TSF WEEKLY INSPECTION FORM

Date: December 2, 2019	Time: 10:15
Weather: -28.1C; 35 km/h NE; sunny	Inspected by: Jennifer Pyluk
Present: Pierre-Luc Sevigny

Placement Area: **Center Cell**

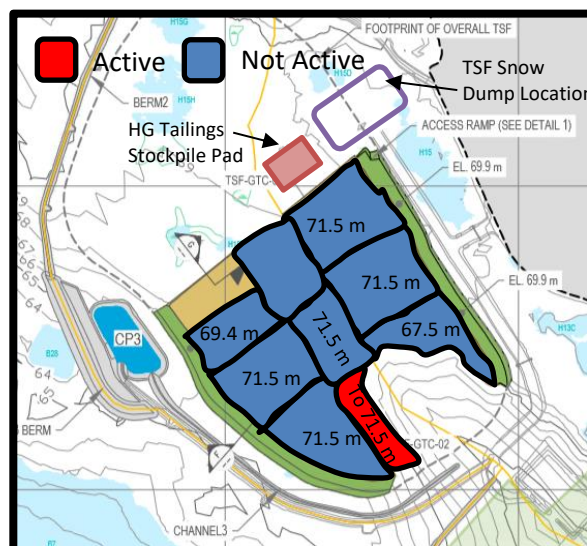
- Tailings placement occurring in the center area between sub-cell 4 and the esker to elevation 71.5 m.
- Although it is understood that the Church continues to be near full, expanded efforts to remove and place the material were observed.

- A light snowfall had occurred the night before the inspection and fewer vehicle tracks across the TSF surface were noted. There were however, some light vehicle and at least one mobile equipment tracks clearly visible across sub-cell 2.

- Tailings being placed in the center cell at the time of the inspection were seen to be “fresh” (unfrozen) as steam was observed to be coming off the material being pushed. Compaction was not observed to be occurring immediately after placement however, and at the ambient temperatures on the morning of the inspection, freezing of the material can be expected to occur very quickly.

- Haul trucks leaving the active area were observed to be trafficking on “undulating” placed tailings. This is expected to be due to unfrozen ground conditions underneath the tailings (as observed from ground temperature readings), incomplete compaction efforts in this location, and freezing/breaking apart of the top few inches of placed tailings.

- Snow removal was on-going from the side slopes of sub-cell 4 and the esker. Snow removal had also been started in sub-cell 1 in anticipation of completing placement in the center cell within the next few shifts.

- Once placement in the center cell is completed, the next area of placement should be sub-cell 1. **All excess snow/ice must be removed from trenches, the tailings/ground surface and the side slopes prior to placement.** This is expected to be difficult in the areas of the trenches, as the material removed to form the trenches has now frozen into place on the side. Heavier equipment (ie. CAT D8) may be required in this area to suitably prepare for tailings placement.

- No additional lifts are to be placed on sub-cells 2, 3, 4 or 5 at this time.
- Winter placement conditions must be followed in order to achieve proper compaction and reduce settlement in the summer months.** This is critically important for placement in sub-cell 1 as the sub-cell is on the edge of the TSF facility and stability of this material is required.

- Tailings must be removed from the Church immediately** to avoid freezing of this material prior to placement. **Stockpiling in the Church should only occur in extreme conditions.**

- Compaction of tailings must occur immediately following placement.** If compacted while unfrozen, the same number of passes (**3 slow passes on high vibrate where “1 pass = 1 forward + 1 backward”**) applies. If frozen tailings material has to be placed, Engineering must be notified so that the least harmful placement location and compaction specifications can be chosen – **frozen/dried tailings must**
